Our Ref: 36/25535

WSC REVIEW OF SYDNEY WATER'S FEASIBILITY LETTER 215 FORBES STREET, DARLINGHURST

Extract from Sydney Water's Hydra system;

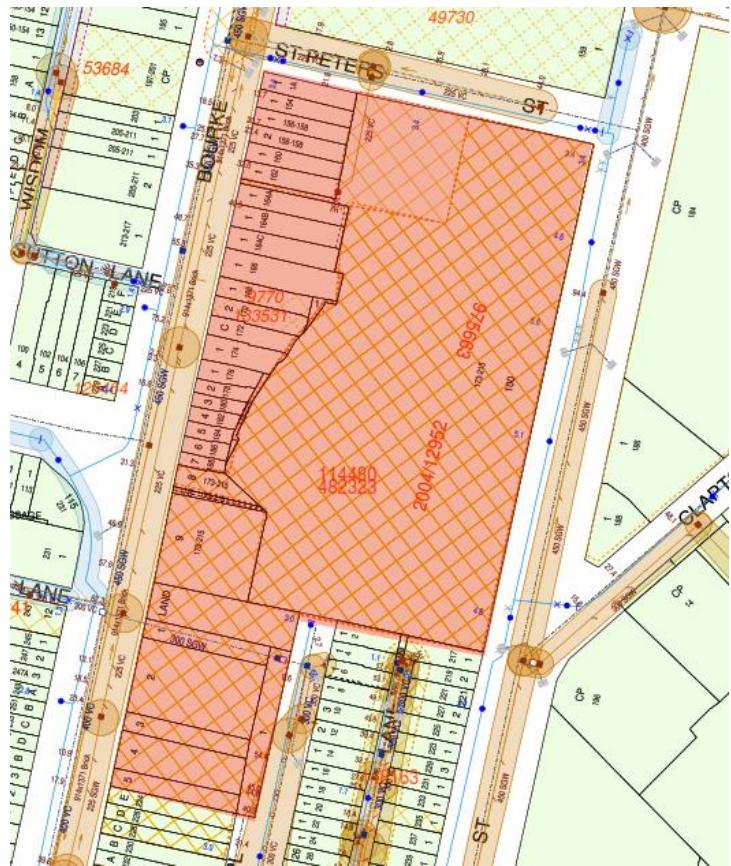
Sydney Water has not provided comments on the preferred connection point for the development. Based on the Sydney Water's hydra system we note that there is a DN225 VC sewer main within the property's boundary at the northern end with an existing connection. If an additional connection is required there is a DN225 VC sewer main in Bourke Street. We will be required to extend the sewer to within the property's boundary. This can be completed under Sydney Water's minor works process.

Sydney Water has made comment regarding the DN300 stormwater pipe traversing the site. The proposed Library building sits over a DN300 SGW stormwater pipe, as per Sydney Water's advice in the Feasibility letter issued on the 3/04/19 no building or structure is permitted to be constructed over the stormwater. With this in mind we foresee two options regarding this matter: -

- Option 1 – The building is to be moved to be 1m from the outside wall of the stormwater asset (and easement where applicable).
- Option 2 – Upon request RAR can investigate the possibility of deviating the stormwater pipe.
